SEC/NG APPROVALS

REVIEW OF CONTRACTOR'S SUBMITTAL

PROJECT TITLE : Construction of New 132/33KV Asir MODON-2 Substation in Asir SOA

Description	Internal & External Handrail Supplier
Reference Specification	As per PTS-22SN181
Manufacturer/Supplier	Sharek Al Daem
Expected Delivery Time

TRANSFORMER RAIL SIZE QU-100

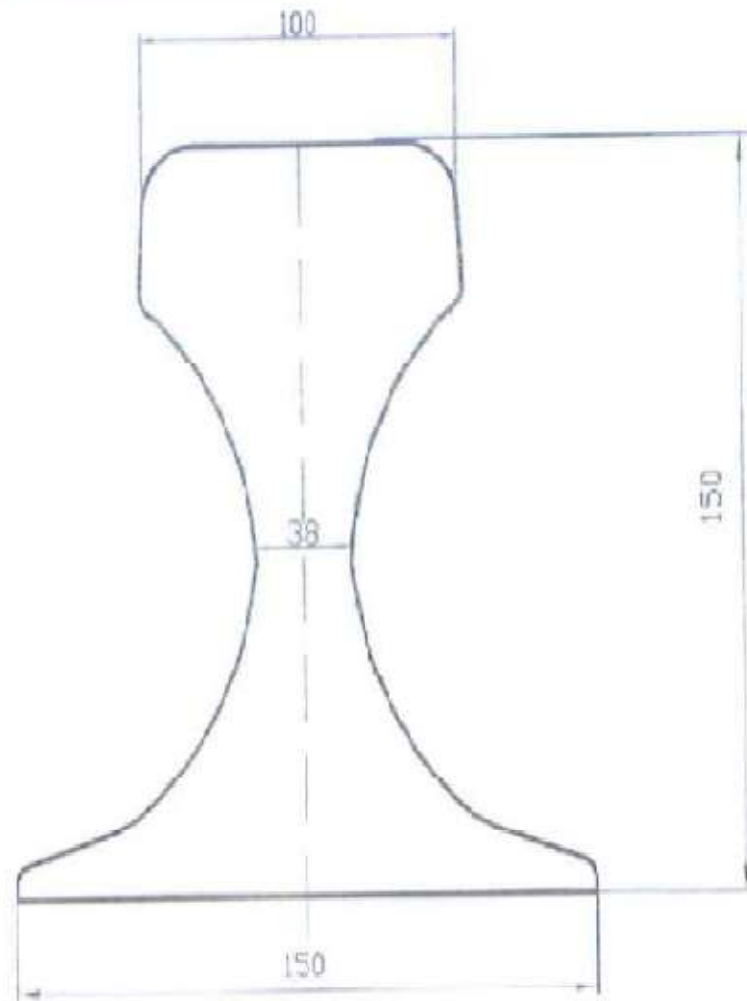
Specification / Drawing No.	: PTS-13EN1104/ Appendix VII
Name and Address of Designer / Manufacturer / Supplier	: _____ : Alshark Aldaem for Contracting
Contact Person Name & Tel No	: _____
Submitted By (Contractor) Signature : _____ Name : Mr. Yousri Mohamed Title : Project Manager Date : _____	Received By (PD/C&EMP) Signature : _____ Name : Hussain Sohail Ahmed Title : Specialist Project Engineer Date : 9/2/17 / 10-Jumada-1438
FOR NATIONAL GRID - SA, PD/C&EMP USE ONLY	
PD/C&EMP HAS REVIEWED THIS SUBMITTAL AND FOUND IT : <input type="checkbox"/> ACCEPTABLE <input checked="" type="checkbox"/> ACCEPTABLE, AS NOTED <input type="checkbox"/> NOT ACCEPTABLE <input type="checkbox"/> CORRECT AND RESUBMIT <input type="checkbox"/> PROVIDE ADDITIONAL INFORMATION <input type="checkbox"/> COMPLY WITH COMMENTS Signature : _____ Name : Hussain Sohail Ahmed Title : Specialist Project Engineer Date : 9/2/17 / 10-Jumada-1438	REMARKS : ① Contractor shall confirm / Ascertain vendor drawing is showing load of less than 230 tons wheel load. ② submit galvanizing certificate
